**CITY OF MADISON  
INTERDEPARTMENTAL  
CORRESPONDENCE**

**To:** Plan Commission  
**From:** Jenny Kirchgatter, Assistant Zoning Administrator  
**Subject:** 1002-1046 East Washington Avenue

**Proposed Use:** Demolish industrial buildings to construct a mixed-use building with 55,600 sq. ft. of office space, 23,300 sq. ft. of commercial space, and 198 dwelling units. Create 3 mixed-use lots.

**PROJECT INFORMATION**  
**STONE HOUSE MIXED USE EAST WASHINGTON**  
 1000 E. WASHINGTON  
 MADISON, WI 53703

**SITE PLAN**  
**C300**

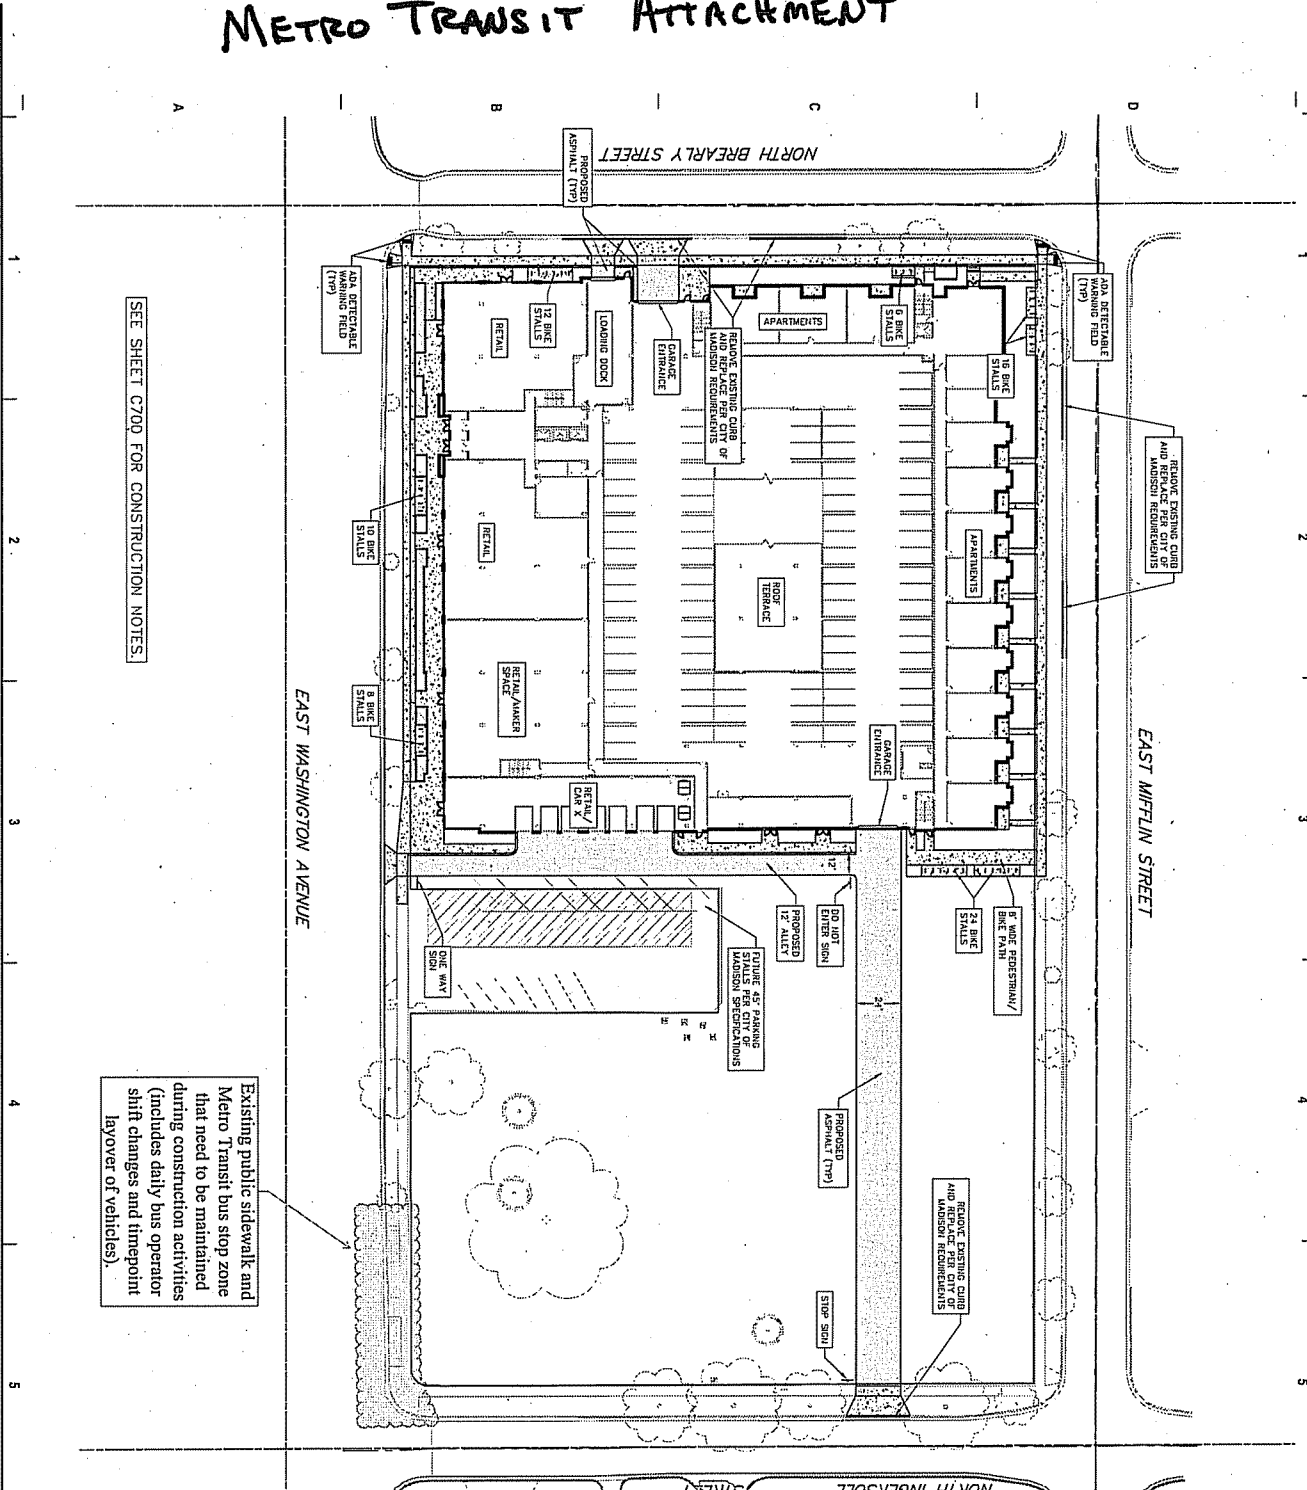
Existing public sidewalk and Metro Transit bus stop zone that need to be maintained during construction activities (includes daily bus operator shift changes and timepoint layover of vehicles).
